**RECALL BULLETIN 563**

**Circolare Tecnica**

**Subject: CLUTCH CYLINDER**

**Product: ALL M.Y. '01 MODELS**

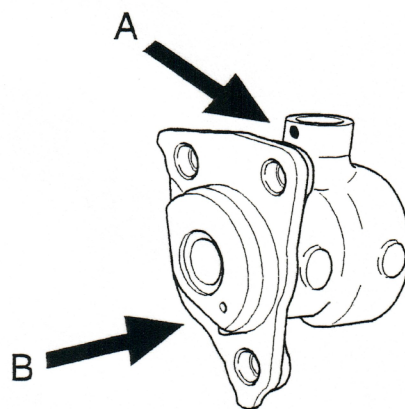
As the a.m. part has been reported faulty —causing clutch control jam—it needs to be replaced.

Clutch cylinder part no. 19540031A will be replaced with a new part having the same number but different features. The new cylinder has a vent (B) on the contact surface with generator cover and a mark (white mark, A).

The clutch cylinder should be replaced during pre-delivery procedures, or recall campaign.

**Instructions for replacement****A Corrosion and irritant hazard.**

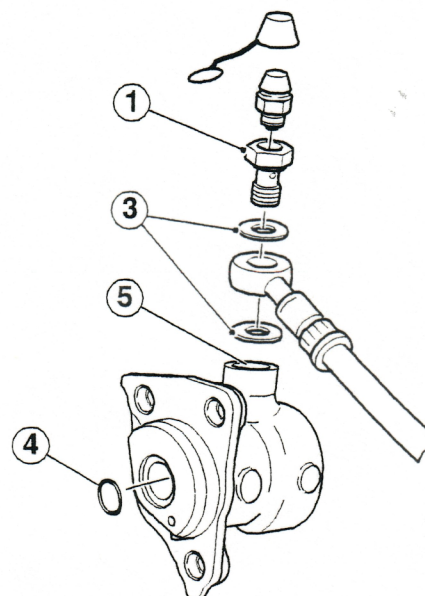
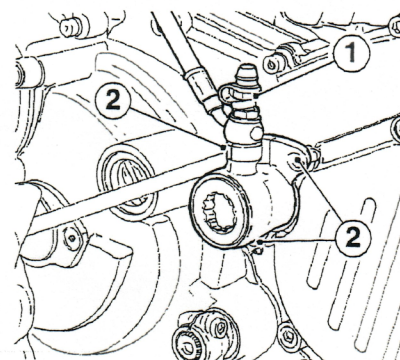
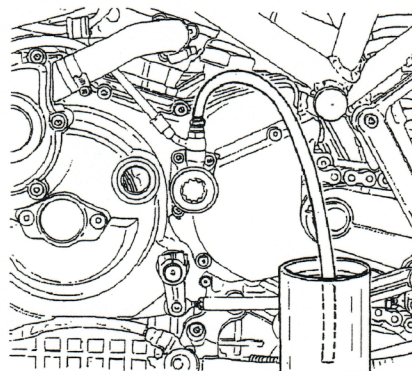
- Connect a piece of transparent plastic tubing to the bleed valve (1) on the transmission unit. Place the other end in a container on the floor holding used clutch fluid.

- Unscrew the bleed valve (1 or 2 turns). Remove the cover with the membrane from the fluid reservoir and operate the clutch lever until all the fluid has been bled out of the circuit.

- Remove the fitting (1) and the three screws (2) securing the cylinder to the alternator cover. Then remove the cylinder.
- Secure the new part to the clutch tube. Fit two new copper seals (3) part no. 42020010A.

- Grease the O-ring (4) and then seat it properly.
- Fit the cylinder. Tighten the three screws (2) to 10 Nm.
- Tighten the bleed valve to the fitting (1) to final torque of 23 Nm.

- Fill the reservoir with specified clutch fluid (SHELL - Advance Brake DOT 4) taken from a new container.
- Bleed all air off clutch hydraulic system as specified in the Workshop Manual.
